Beaver Valley Power Station - Units 1 & 2

Annual Radioactive Effluent Release Report

Unit 1 and 2 Offsite Dose Calculation Manual Changes

Change (20) to the ODCM (Effective October, 2003)

ATTACHMENT D
Page 1 of 3
LIQUID RADWASTE SYSTEM

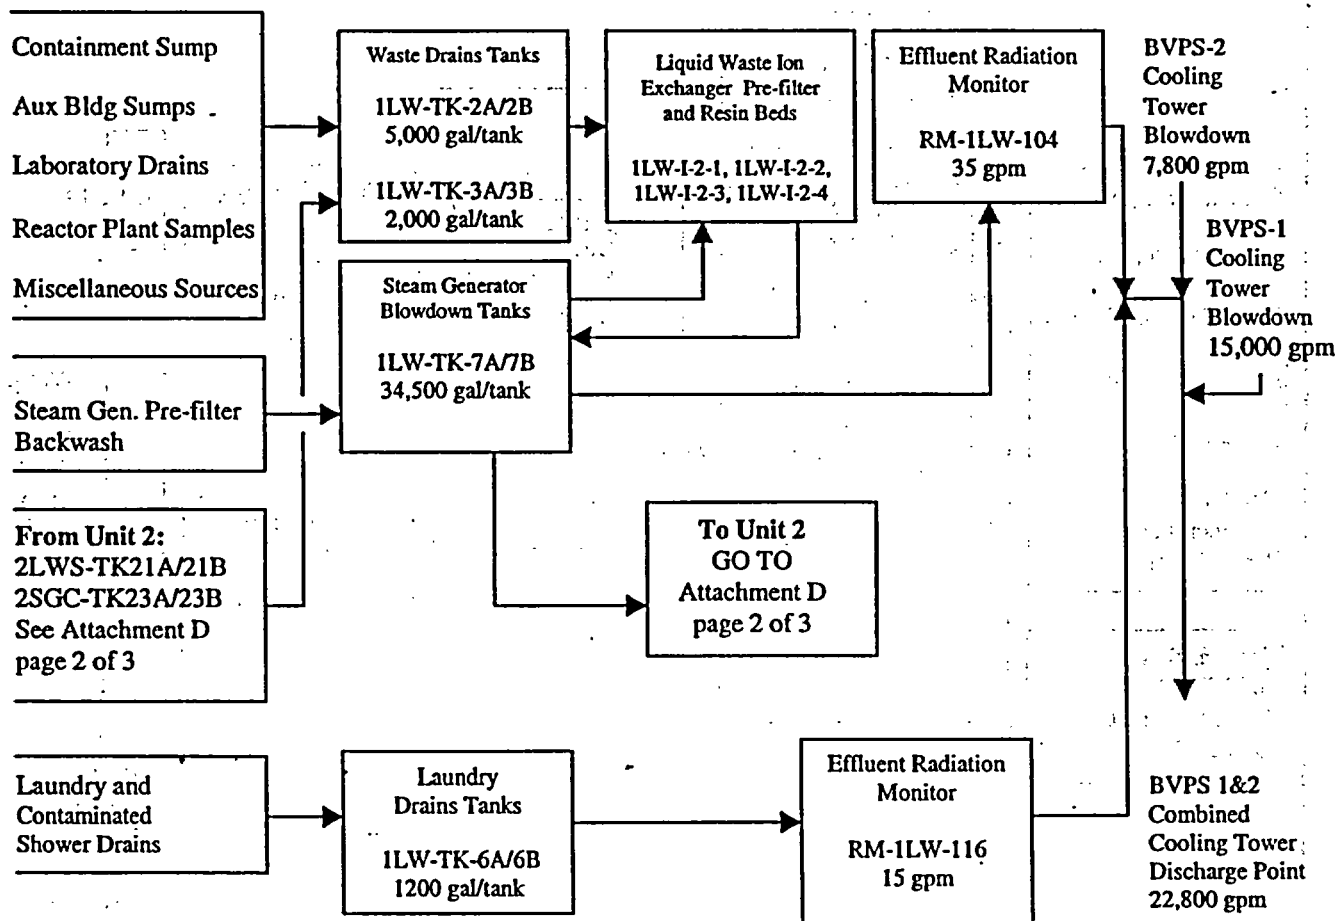
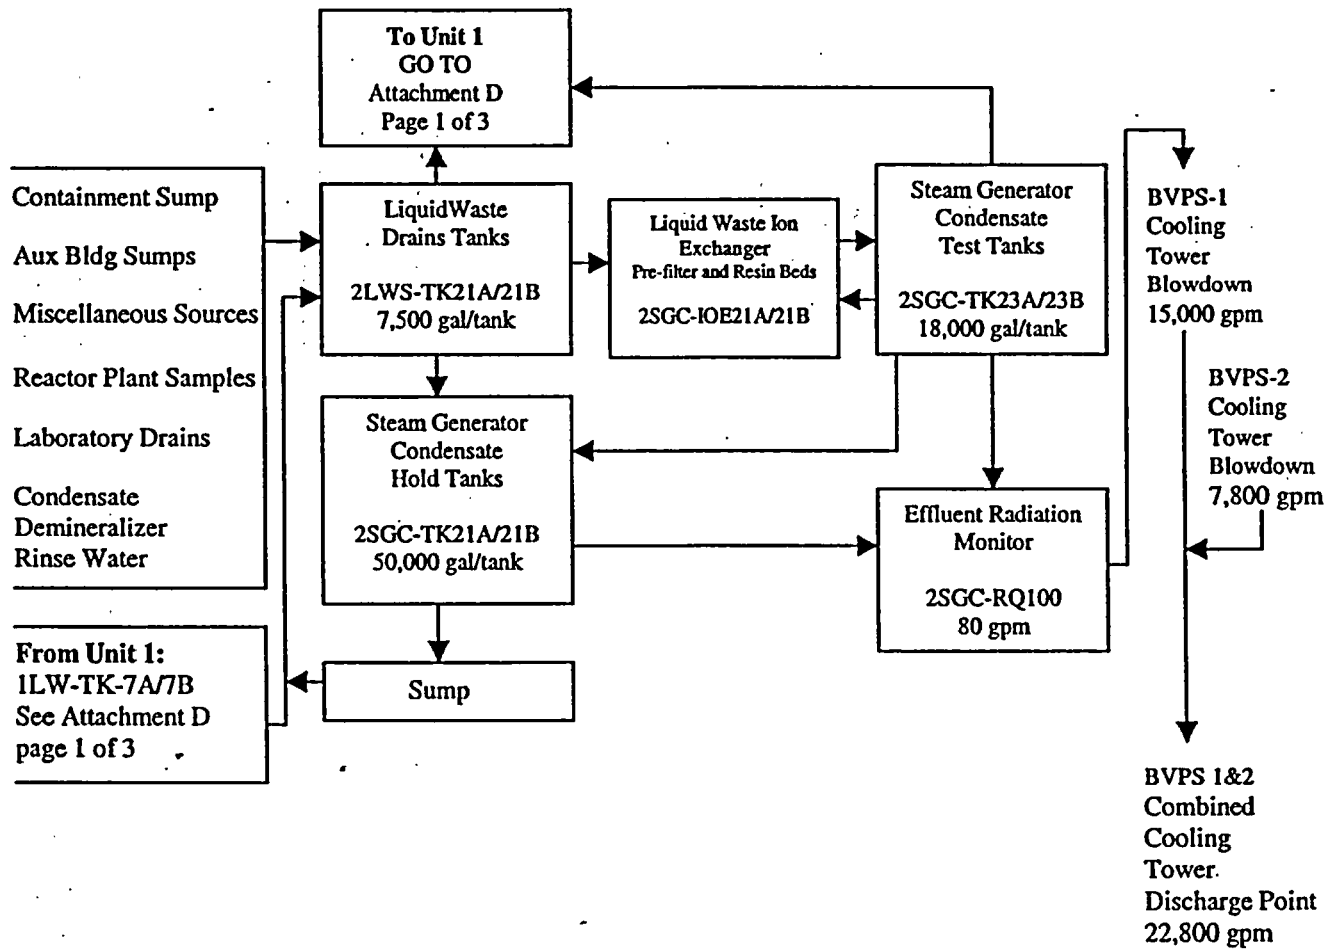
- 1) **Procedure 1/2-ODC-1.01:** Updated the History of ODCM Changes to include this change.
- 2) **Procedure 1/2-ODC-2.01:** Updated Liquid Waste System diagrams to indicate the flow path for cross-connect of liquid waste between Unit 1 and Unit 2, and to denote use of a charcoal Pre-Conditioning Filter to the Liquid Radwaste Treatment System.
- 3) **Procedure 1/2-ODC-2.02:** Updated the source-term for Unit 1 containment vacuum pumps.
- 4) **Procedure 1/2-ODC-3.03:** Updated the Preplanned Method of Monitoring when the mid range and high range noble gas effluent monitors are inoperable. Updated the activity limits for liquid storage tanks. Added clarifications to gaseous effluent pathway sampling tables.

3.2.2.15	CR 03-02466, RFA-Radiation Protection Effluent Control Provide Recommendation on Processing when Performing Weekly Sample of [1LW-TK-7A/7B]. CA-02, Revise ODCM Procedure 1/2-ODC-2.01, (Attachment D) to show the liquid waste flow path cross-connect between Unit 1 and Unit 2.
